Historical Architectural Review Board
COA Final Review Sheet

HDC-2023-00043

Address: 347 N. 8th Street

Proposal: Install surface-applied window signage at storefront

Rendering of signage in the three proposed locations of the storefront.
(Applicant)

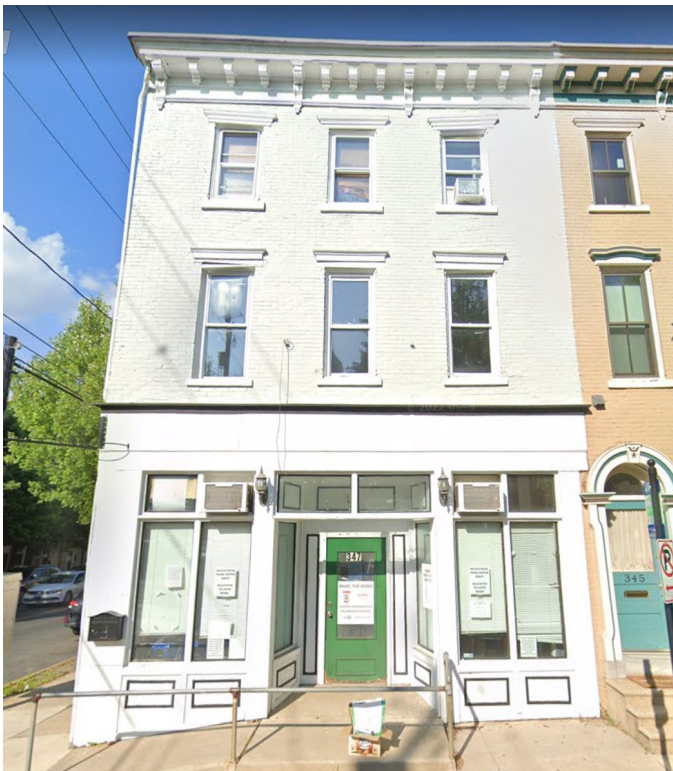
The design guidelines support the installation of surface-applied window signage with transparent backgrounds, because the signage type does not damage historic materials. Staff questions whether the sign in the transom includes an opaque background and suggests that no background color be included. Provided none of the signage includes opaque backgrounds, staff finds the application complies with the design guidelines for commercial storefronts, and more specifically with Guideline 3.13.18.

The HARB discussed the appropriateness of the proposed signage and inquired whether the sign in the transom would have a transparent or opaque background. Ms. Manzueta confirmed that the sign would have only letters and would include no background. The HARB requested that the lettering be centered across the transom and not contained on one pane of glass so that it was more symmetrical. Ms. Manzueta agreed to the request. The HARB found that the signage complies with the design guidelines.

Approval, provided no signage contains an opaque background, with the staff to review details, pursuant to Chapter 3, Section 3.13 Commercial Storefronts.

Mr. Jordan moved to approve the application presented on 7/10/2023 for the installation of surface-applied window signage at the storefront of 347 N. 8th Street, with the staff to review details, provided the lettering is centered across both transom lites and the background is transparent, pursuant to Chapter 3, Section 3.13 Commercial Storefronts. Mr. Lichtenwalner seconded the motion, which passed with unanimous support.
